## PRODUCT CHANGE NOTIFICATION

Date: August 12, 2014  
PCN: PCN LEDIL 97 a, b

**Subject:** PCN 97a - CS12862\_STRADA-IP-2X6-DWC product improvement

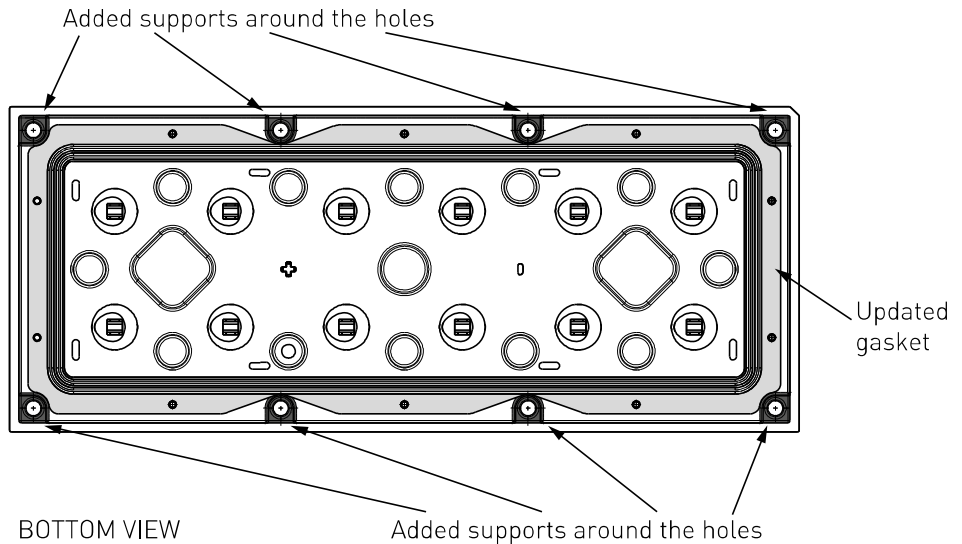
**Changes:** There are added supports around the eight fastening screw holes and the silicone gasket has been replaced to the latest version. There aren't any changes made into optical parts of the product. Please see the below drawing for details
